Planning Section  
Clare County Council  
Ennis

15 Mar 2022

**Re - Submission on Lands VGA 1 at Parkroe, Ardnacrusha, Co Clare - Clare County Council Draft Development Plan 2023-2029.**

Attachment A

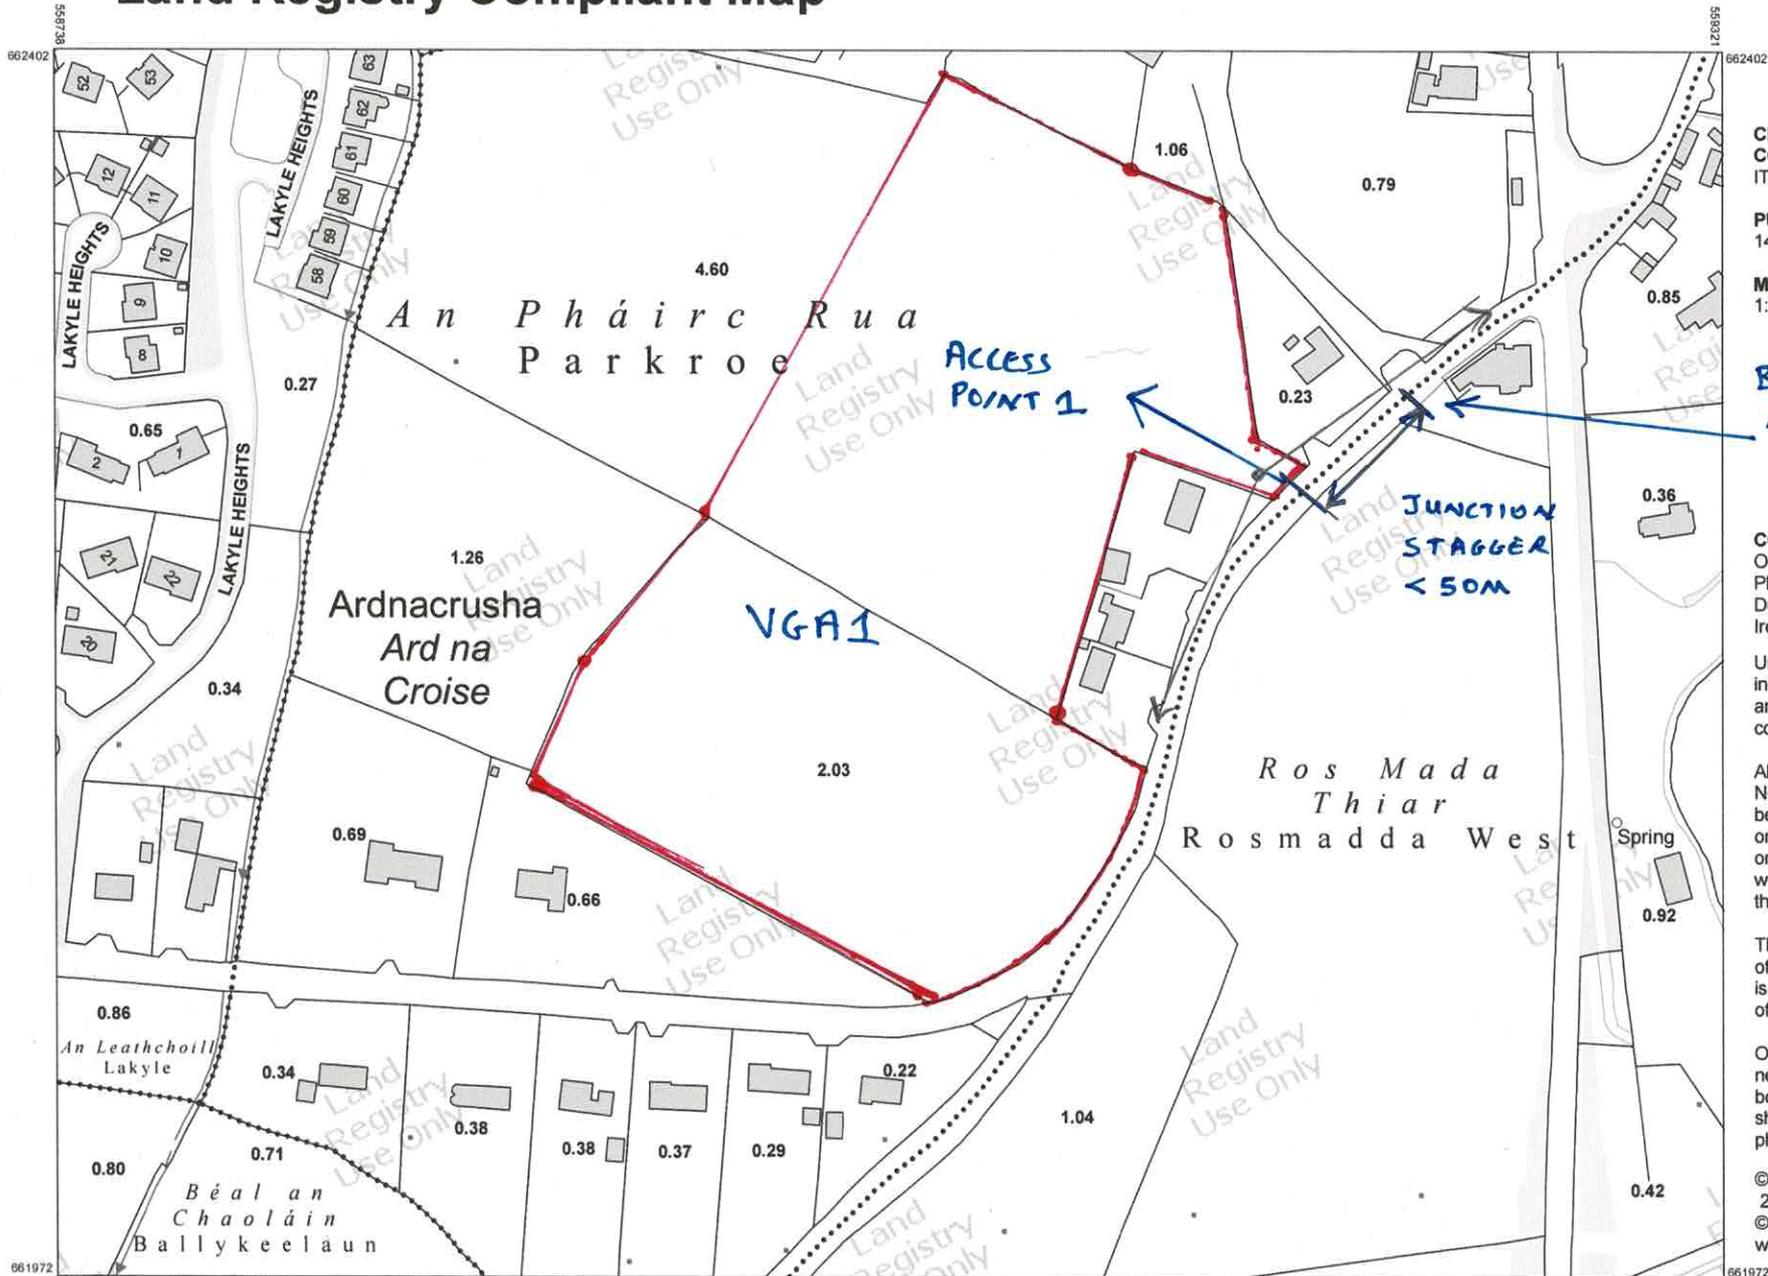
Attachment A shows 2 possible access points from VGA1 lands to the public roadway.

**Access Point 1**

This is located to the eastern end of the site adjacent to Barry shop. Design guidance DN -GEO-03060 "Geometric Design of Junctions" from Table 5.2 the minimum stagger distance between priority junctions is 50m. There is already a busy access from the rear of Barry's shop that is approx 45m from the notional new Access Point 1. In addition there are 4 private house entrances adjacent creating multiple traffic conflicts. Thus this possible junction would be non compliant and unsafe.

ATTACHMENT B

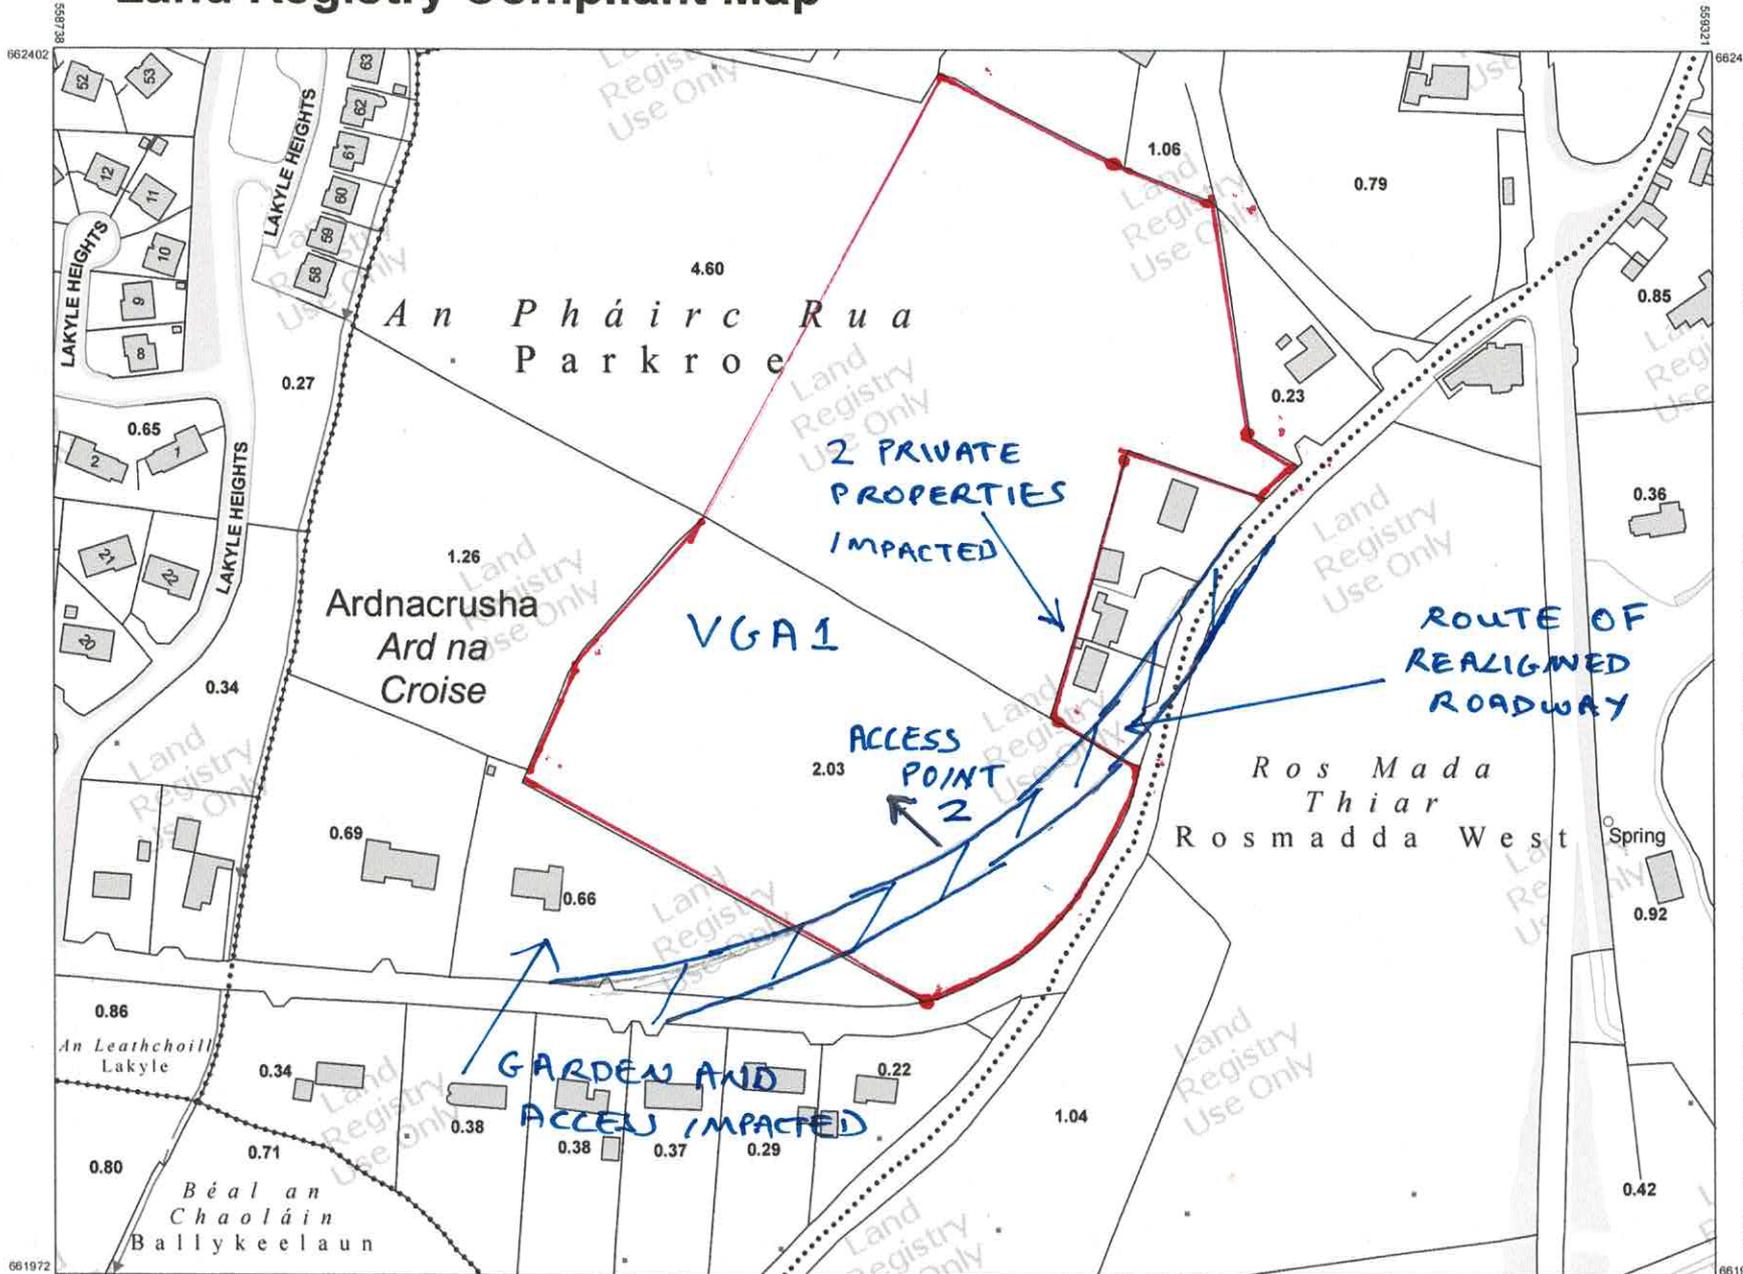
In addition for the road design speed of 60kph, 90m sight distance is required. To achieve this will require removal of the entrance walls and gateways of the two adjoining dwellings to the north and a section of the property to the south. This is illustrated in Attachment B.
